Subject: Amendment No. 1 to Clean Water Act Section 401 Water Quality Certification No. R9-2017-0004 for the Trampas Reservoir Project

Amendment No. 1 to Clean Water Act Section 401 Water Quality Certification No. R9-2017-0004

PROJECT: Trampas Reservoir
Certification Number R9-2017-0004

Exhibit 4

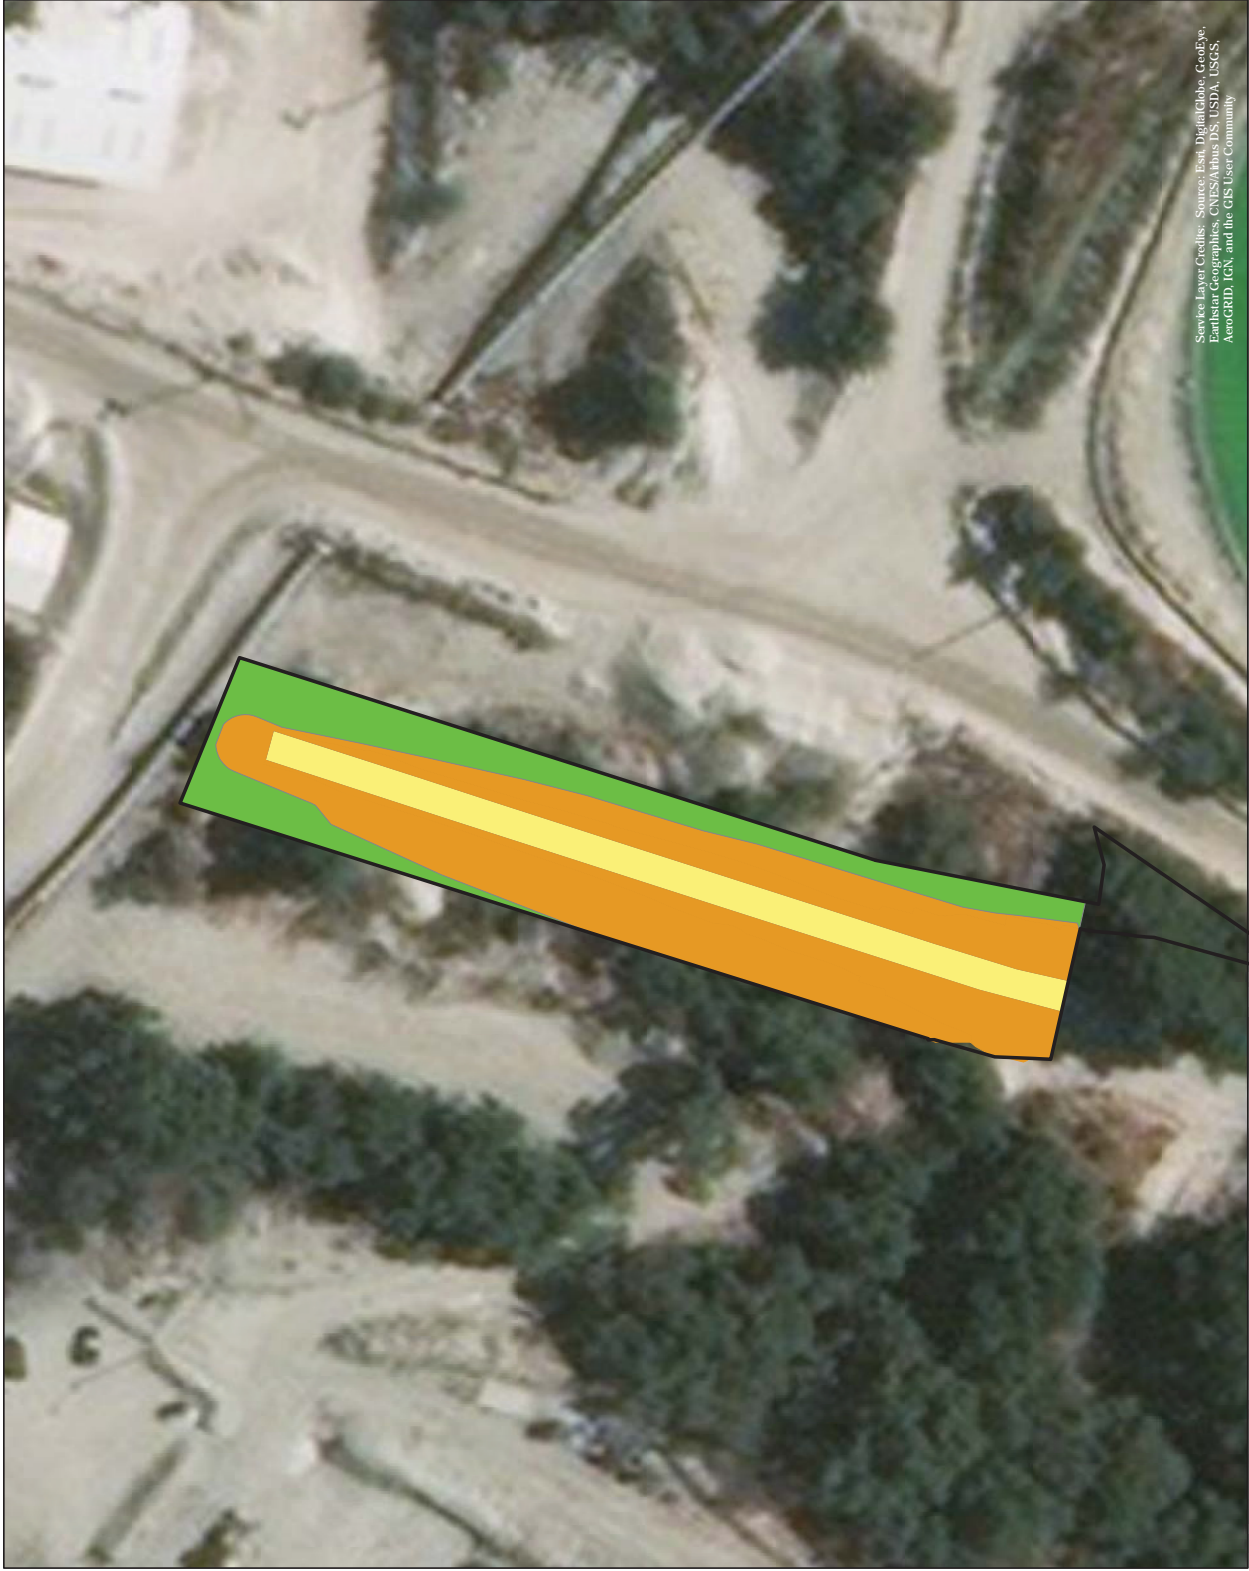
Based on the Applicant's request, the California Regional Water Quality Control Board, San Diego Region (San Diego Water Board) is amending the Certification to authorize impacts to an additional 0.24 acre (440 linear feet) of ephemeral streambed waters of the United States and/or State. Mitigation for permanent impacts to 0.24 acre of ephemeral Waters of the U.S. will be mitigated through enhancement of 0.24 acre of giant reed within San Juan Creek for a ratio of 1:1. There will be no loss of waters of the United States and/or State as the ephemeral streambed will be reconstructed on-site and revegetated with southern coast live oak riparian (SCLOR) woodland with an herbaceous understory.

Performance Standards. Compensatory mitigation required under this Certification shall be considered achieved once it has met the ecological success performance standards contained in: (1) the Mitigation Plan (Section 2.9, page J-38) to the satisfaction of the San Diego Water Board; and (2) *Trampas Reservoir Stream Restoration and Monitoring Plan (SRMP)* (Page 11, Section VI.A) (Glenn Lukos Associates), dated May 7, 2018 (Revised May 16, 2018) for permanent impacts to 0.24-acre (440 linear foot) of southern coast live oak riparian forest within a segment of Trampas Creek immediately downstream of the Trampas Reservoir.
